APPENDIX G

Review Comments and Responses

Project Name: SR-710 Tunnel Technical Study Draft Rpt

Project Phase: Task Order No.4 – Draft Report

Figure 1

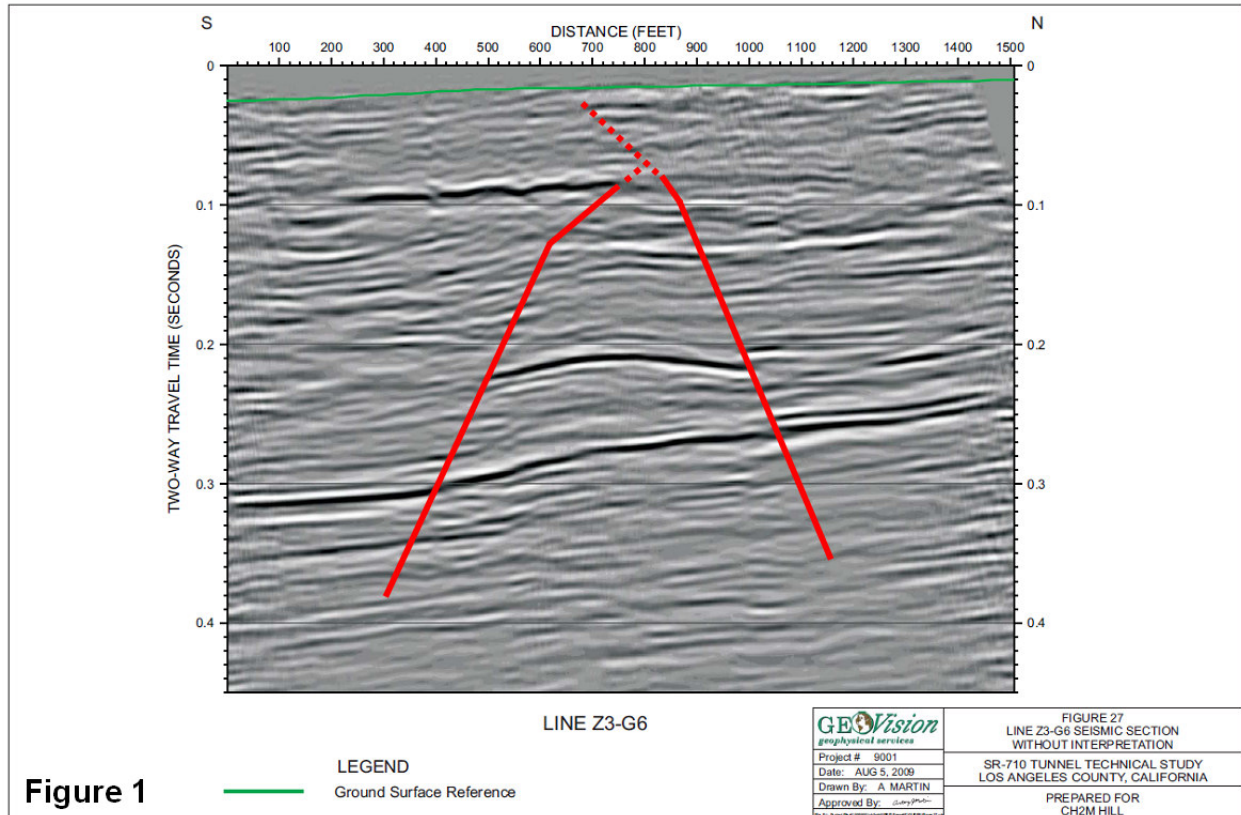
As an example, the Highland Park fault is considered not active in the Draft Report (see section 8.4 Faulting), but little previous engineering geologic information had been developed along the fault where it is covered by young alluvium. Where the Highland Park fault is crossed by seismic reflection line Z3-G6, there seems to be a clear indication that the interpreted buried bedrock surface is offset between stations 700 and 900 (distances along the line in feet) based on the termination of the very clear reflector south of station 750. This offset also appears to extend into the overlying alluvium where reflector continuity appears to be affected (reflectors appear truncated, folded, and arched) in this interval (see Figure 1 below). This seems to be an example

of the lack of time for complete analysis of the geophysical data by Certified Engineering Geologists (CEG) to bring a geologic perspective to this important data. Such reinterpretation of all seismic reflection profile lines must be conducted by a CEG and properly documented before the Final Report is prepared.
